Dear editor,

## Reply to Reviewer number 1, Anonymous review

- We changed the title to: *Evaluating the performance of a cost effective in situ methane sensor for UAS-based systems and its ability to quantify facility-scale emissions.* In this case, the title is less generic and incorporates the general comment of this reviewer and anonymous reviewer number 3.

Line 144: "Figure 1"

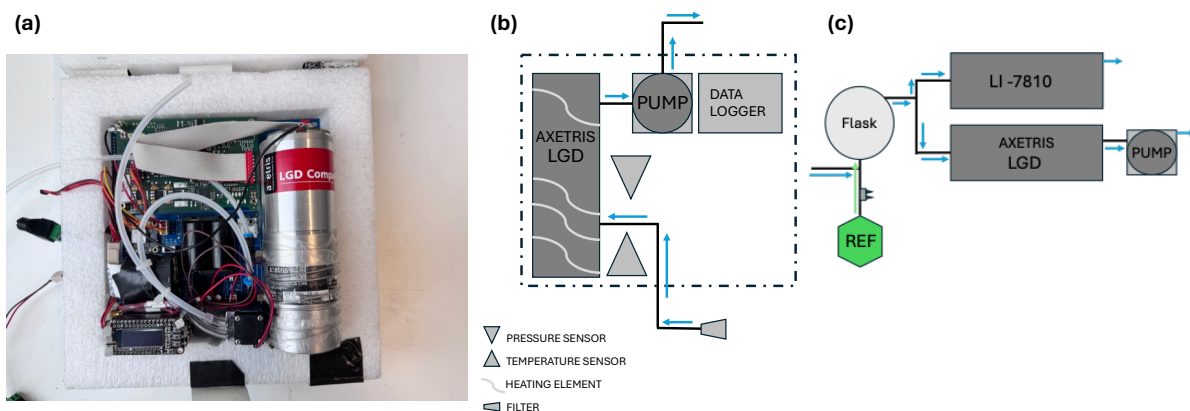
- Consider including an annotated photograph of the sensor package (highlighting the inlet and outlet). This may be included as a subfigure of Figure 1.
  - Revised and added to Figure 1. We decided to leave out the highlighting of the inlet and outlet since this did not make the Figure clearer. Figure one is updated to:

- What does "REF" stand for in this figure? Is it defined in the main text?
  - We added the meaning of REF to the figure caption. The complete caption of Figure 1 now reads: "Figure 1: a) Photograph of the Axetris package. The different colours visualise the flow of air through the sensor. Blue represents the path of the air entering the Axetris sensor. Orange represents the connection between the Axetris and the pump and green represents the outflow of the air. b) schematic overview of the Axetris package for UAS applications. The blue arrows show the airflow through the system during measurements. Components in the dotted and dashed lines enclosed area are integrated onto the PCB and enclosed in the PE foam. The datalogger communicates with the Axetris sensor and provides active control of the heating element, including setting and maintaining the desired temperature. c) Experimental overview for linearity test setup. First, the flask is filled with the reference gas (REF), which has a high CH<sub>4</sub> concentration (indicated by the green arrow). Then, both systems start to sample the air from the flask, while ambient air was drawn in to mix with the high concentration (blue arrows), slowly decreasing the concentration in the flask."

Line 166: "Linearity of the Axetris"

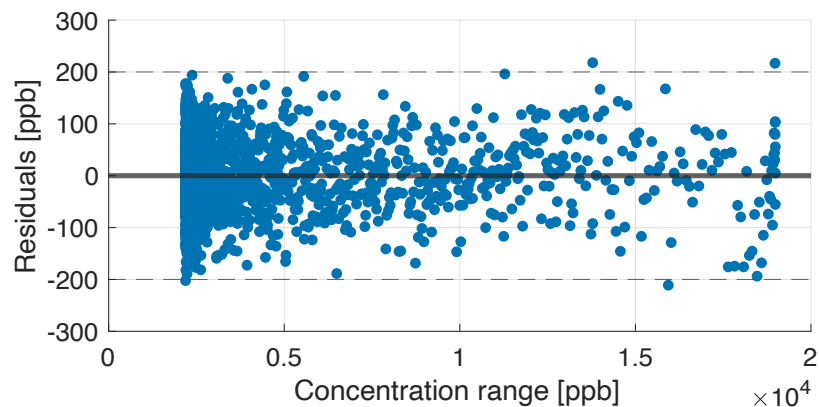
- This subsection (in its current format) does not provide an evaluation of the linearity of the measurement, but rather provides a calibration of the instrument. A linearity test shows whether the increase in one measurement is consistent with increase in a second measurement, following a linear regression. The magnitude of any derived linear coefficients is independent of the standard of linearity.
  - We added a plot of the residuals between observations and the linear fit to show the sensors linearity (i.e., neutral, non-wavy noise around the linear fit) over the observed concentration range. We believe this sufficiently demonstrates the linearity of the Axetris. The following figure is added to the Appendix as Figure B2:

Line 167: “high CH<sub>4</sub> concentration (~81ppm)”

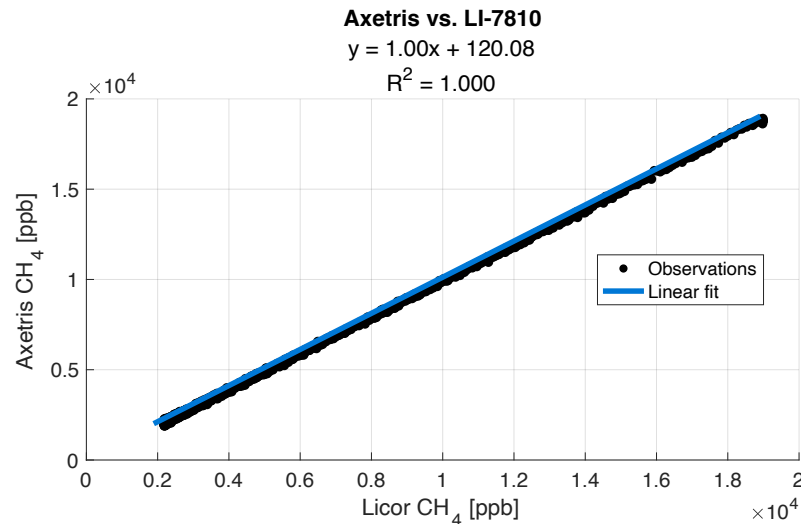
- If this is the case, why is Figure B1 plotted between 0 ppm and 2 ppm? Why not plot it up to 81 ppm?
  - We used 81 ppm to increase [CH<sub>4</sub>] in a mixing vessel to ~21 ppm. Gradual reduction back to background concentrations yields a range from 20 ppm to 2 ppm. For clarity we have removed from the figure the initial (at the start of the experiment) rise from 2 to 21 ppm that, confusingly, was originally visible as a S-shaped trace (due to difference response times of the two sensors). Only the gradual, monotonous decay of concentrations back to ambient is now plotted.
  - The updated Figure (Figure B1) is as follows:

Line 249: “Figure 2”

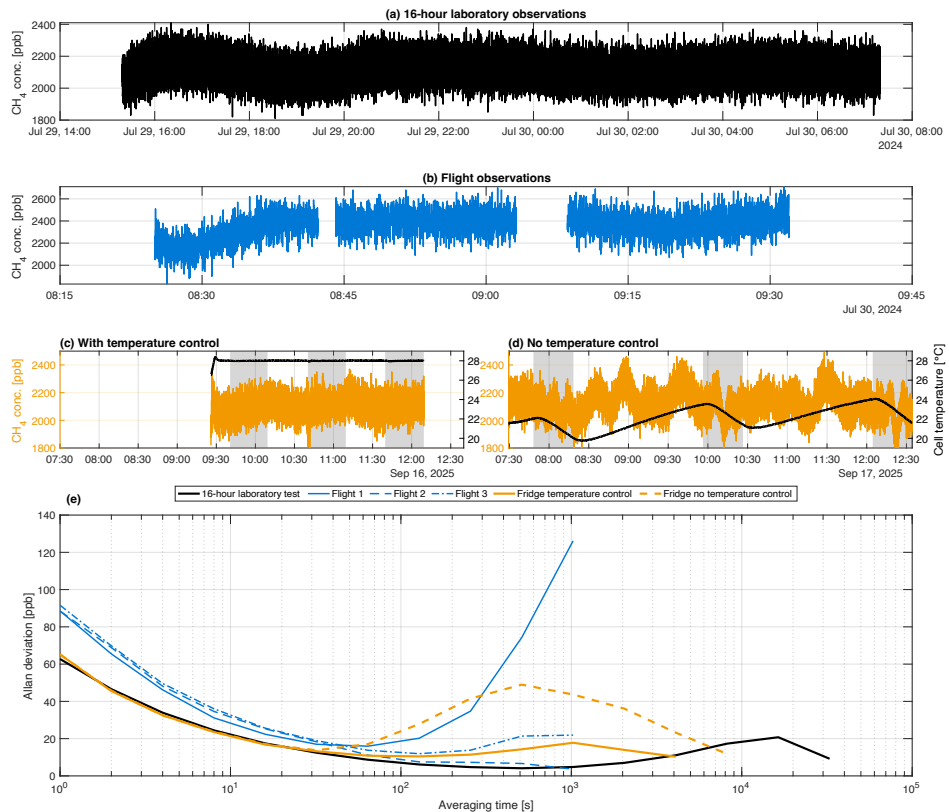
- The title for the horizontal axis title should either be the correct Greek symbol ( $\tau$ ) or be replaced with the text “averaging time”.
  - Revised and changed the xlabel to averaging time.
- It might make more sense to change the colour of subplot b and then to use consistent colours in subplot d. Otherwise it is confusing because different colours mean different things in the four subplots.
  - Revised and changed the colours to match. The revised figure

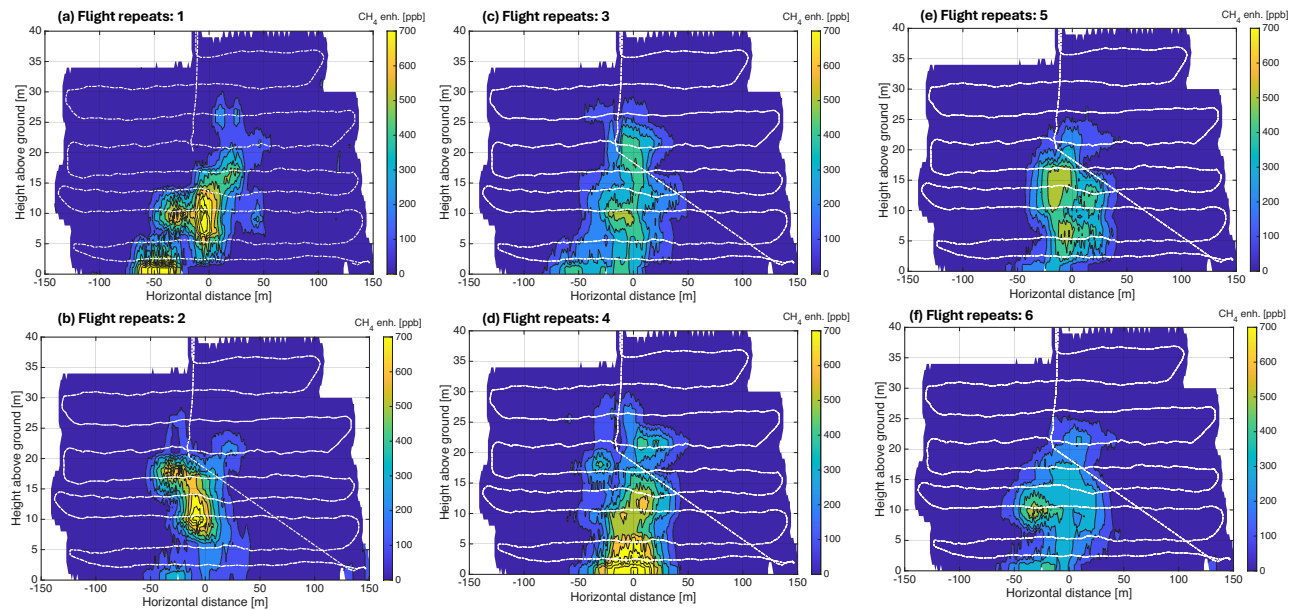
- A fundamental requirement of this approach is the assumption that the emission plume does not move during sampling. This method assumes that turbulence does not change the location of the plume and that the wind direction does not change. Please discuss this here as a caveat to this approach.
  - This is not the case. Turbulence and location variability would yield a broader, more sparse or even non-contiguous and less intense contour plot of identical integral. We acknowledge that this result may not be intuitive. We attempt and clarify and illustrate this in Section 4.2.1: we added a six-panel figure in the Appendix (Figure K2) showing the integral approaching a clean Gaussian after six repeated samplings of the same variable plume.

- I disagree. If enough sampling is conducted, Gaussian plume methods can also deduce the average emission flux, as a turbulently moving plume and the UAV randomly intersect. These random intersections should average out over time. It certainly isn't better for a non-Gaussian approach, such as for the grid-square averaging approach in this work. The assumption in this work is that each grid square will include a statistical sample of the moving plume as well as the background.
  - Certainly, given enough sampling, both methods converge. Indeed, we show in an added figure FigureK2 that our 'local interpolation' method does converge

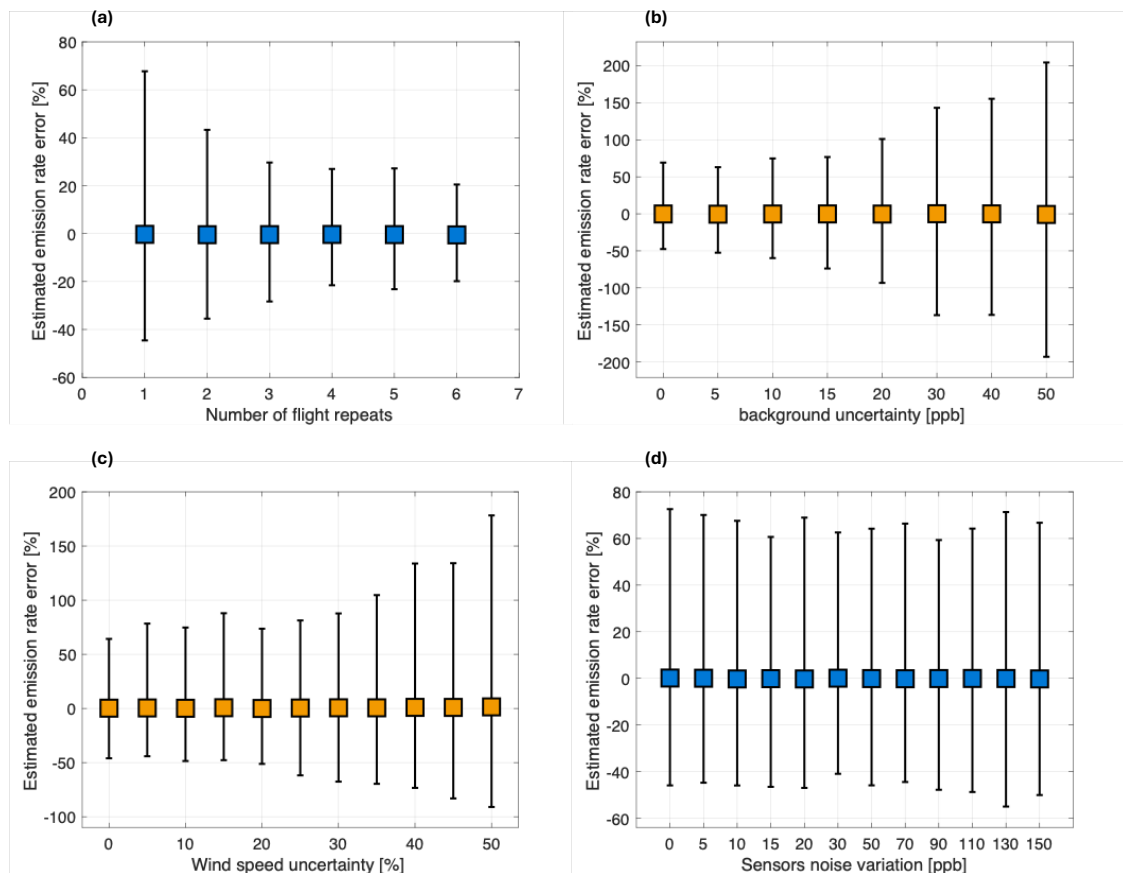
- Why not combine Figure 4 and Figure 5 into a single figure with four subplots?
  - We decided to combine both Figures, resulting in the following Figure and caption:

Line 933: “Figure B1”

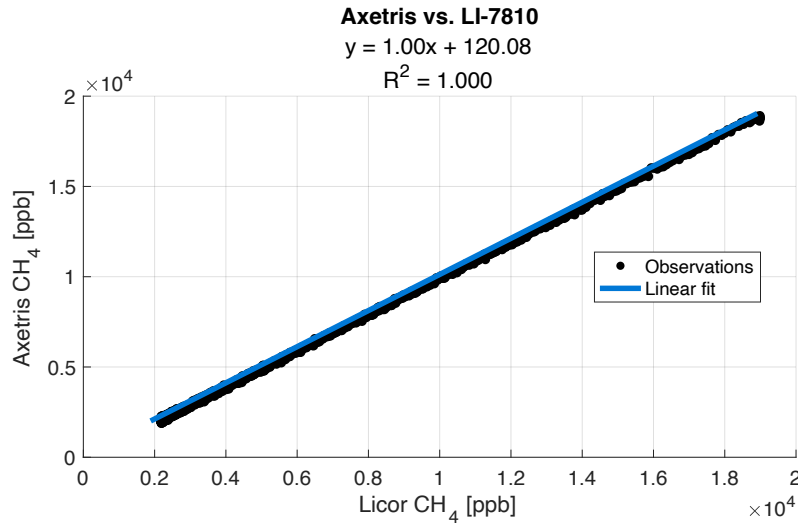
- A calibration conducted between 0 ppm and 2 ppm (according to Figure B1) was applied to UAV sampling conducted up to 3 ppm. It would make more sense to sample higher methane mole fraction levels during this calibration. Furthermore, the mole fraction range presented in Figure B1 is inconsistent with the description of the experiment provided in the text, which instead suggests that sampling was conducted up to 81 ppm. This is clearly not the case from Figure B1.

- It is really difficult to distinguish the line from the points. Perhaps make the line bright red with small black dots for data.
  - Revised and changed the line to blue to match the colour scheme of the manuscript

- A related question on the Figure B1 (page 30): why do the outlier points in Figure B1 seem to lie on a hyperbolic tangent-like curve rather than on random distribution around the straight fitting line? Perhaps it’s my limited understanding, but I don’t think there’s an explanation in lines 167-181 for this hyperbolic tangent-like data.

- Dear reviewer, thank you for the comment. The curve depicted in Figure B1 shows a range of 2 to 20 ppm, and therefore also incorporates higher methane mole fractions. We changed the axis labels from ppm to ppb to state this more clearly. The description is still correct but due to the mixing of the high concentration air with ambient air, the actual recorded starting concentrations is closer to 20 ppm instead of the 81 ppm inside of the tank. Additionally, please note that this procedure does not constitute a calibration, but rather a characterization of the sensor's linearity.

- o This is an artifact of the difference in the response time. The data included the entire time series of the experiment, which starts with sampling ambient air and then rises to the high emission inside the flask. The Axetris simply reaches that plateau sooner. To remove the hyperbolic-tangent-like data (which are not meaningful for the experiment), we decided to remove the observations associated with the rise. This resulted in an updated Figure B1, which can be found in the updated manuscript. Removing the tangent-like behaviour also changed the linear equation, which is updated as a result of the change.

#### Geoplot of flight track and wind direction

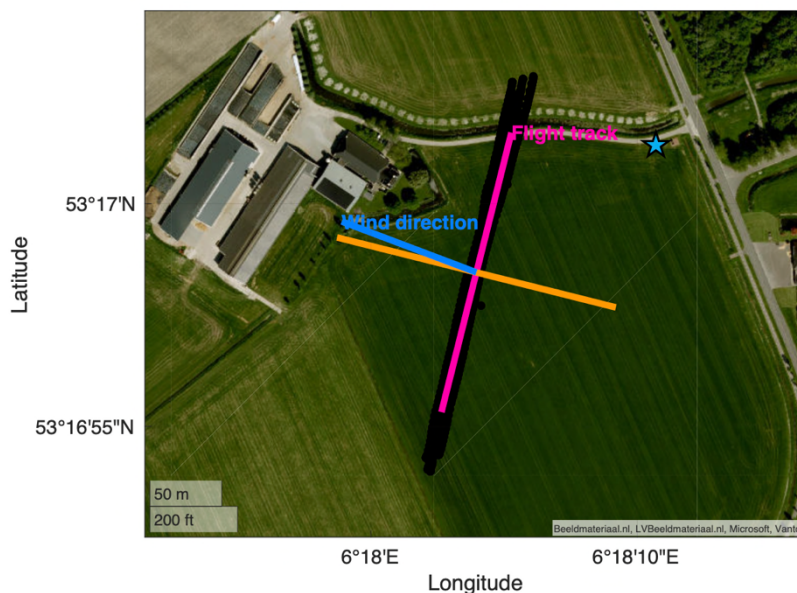
- Revised and we moved the information about the flight plan to section 3.5 (flight strategy). This section now mentions the distance between the source and the observations and also the number of transects and height above ground: “The flights were conducted under light to moderate wind conditions ( $3.7 \pm 1.4$  m/s, NW to WNW; Appendix E) and consisted of 12 transects between 4 and 60 m above ground level at approximately 120 m downwind of the farm (Appendix H).”
- Thank you for pointing it out. We changed all figures in Appendix H to only show the UAS position (black) instead of the CH<sub>4</sub> concentrations, and we changed the caption to complement this. We agree that the CH<sub>4</sub> concentrations were hard to read and adding them to this top down view does not add any valuable information. All figures now look something like this:

Figure L1: Overview of the individual sources of uncertainty and their respective effect on the estimated error based on an emission mass emission rate of 1kg/hr.

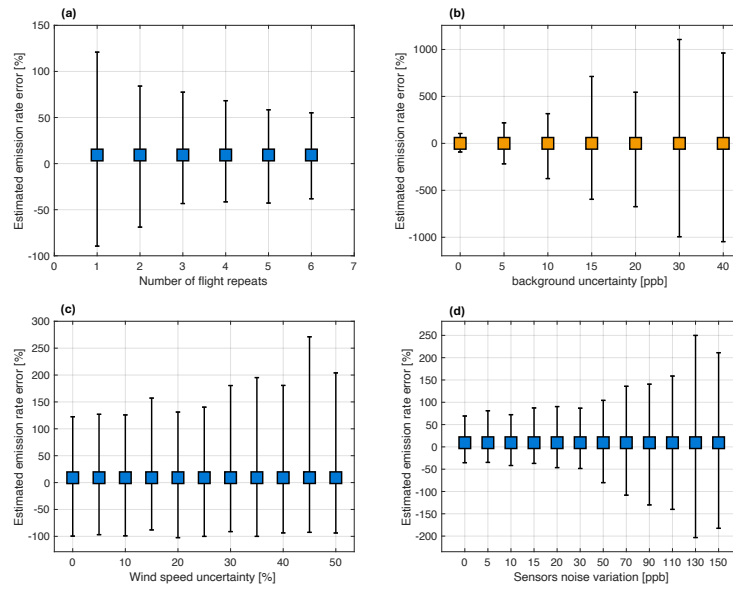
Line 676-691: I agree with the interpretation that the uncertainties associated with noise level and background concentrations estimate will probably be the factors that play a role in the dependency of the uncertainty to the emission rate. However, this would have been preferable to perform the same analysis for each individual source of uncertainty, to really justify this assumption.

- Thank you for pointing this out and we understand the critique. However, we tried to address this concern by pointing out that by increasing the flight repeats (e.g. fly more during the same day) the uncertainty at low emission rates benefits more compared to higher emission rates by stating “random errors are effectively averaged out through repeated sampling.” Additional meteorological errors play a bigger role when emission rates increase, and noise and background uncertainty have less of an influence (since percentually, it would be difficult to be off more). The uncertainty of each individual source was conducted in section 4.2, but at lower emission rates.
- We did add an additional Figure to the Appendix L showing the effect of each individual source of uncertainty for a source of an emission mass rate of 1 kg/hr and referred to it at the end of the statement:
